U.S. Department
of Transportation
**Federal Highway
Administration**

In Reply Refer To:
HSSI/WZ-250A

This is in response to your February 10 correspondence requesting the Federal Highway Administration's (FHWA) acceptance of your company's DL1000L, DL1000W, SDL1000L and SDL1000W sign stands as crashworthy traffic control devices for use in work zones and elsewhere on the National Highway System (NHS). Accompanying your letter was the FHWA Office of Safety Design form explaining the differences between these stands and previously accepted stands was the material (steel v aluminum) and the length (22 inches v 30 inches) of the legs. You also noted that all changes to the stands are below the bumper line of an impacting vehicle. You requested that we find these devices acceptable for use on the NHS under the provisions of National Cooperative Highway Research Program Report 350 "Recommended Procedures for the Safety Performance Evaluation of Highway Features."

This enquiry is in regards to a request that should have been made in conjunction with our WZ-250 submittal. During this submittal a large number of aluminum legged stands were approved with the substitution of steel legs. Tw

Figure 7. System Nos. 5 and 6 Sign Support Details, Test D-3

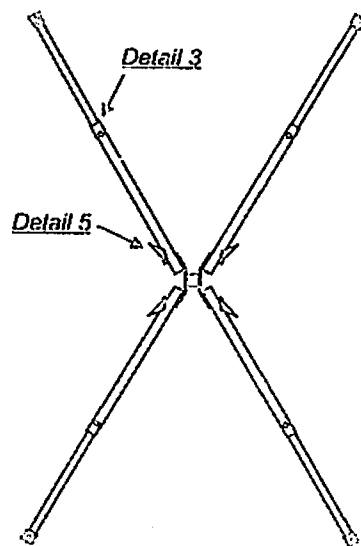
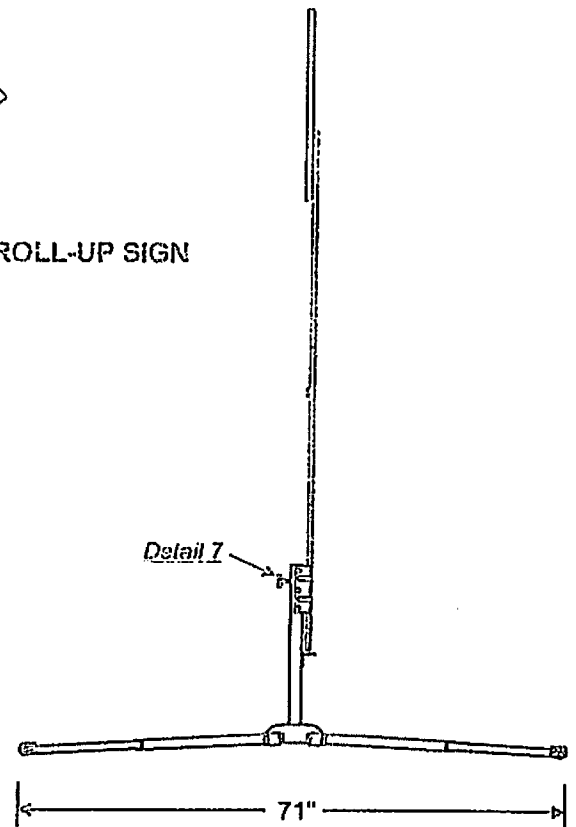
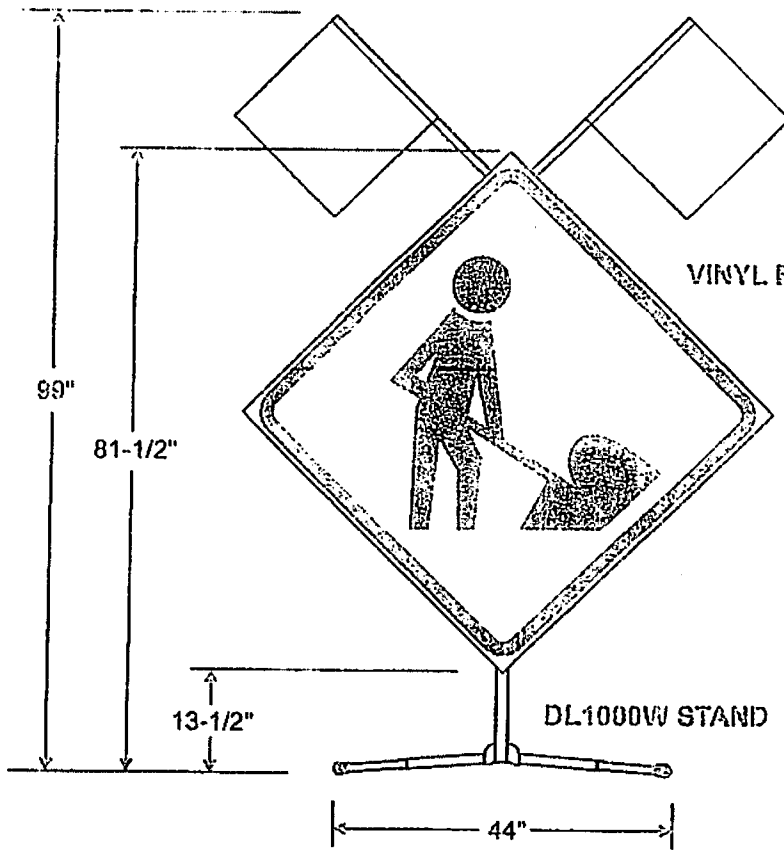
We believe this to be a reasonable request because the design differences all occur below the height of the vehicle bumper. As such, we contend that they will have no effect on the windshield impact data.

DL1000W STAND

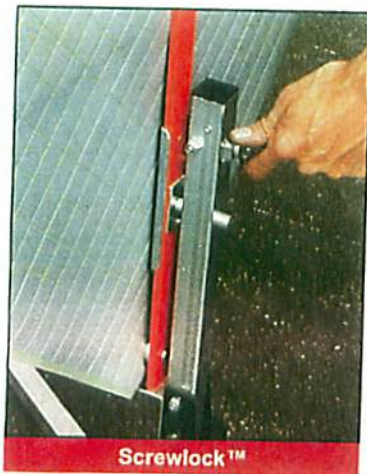
- ⊙ Base- 1-1/2" sq. steel tube with 3/16" steel leg flanges
- ⊙ Legs- Telescopic 1-1/4" and 1" sq. aluminum tubing with .100" wall thickness
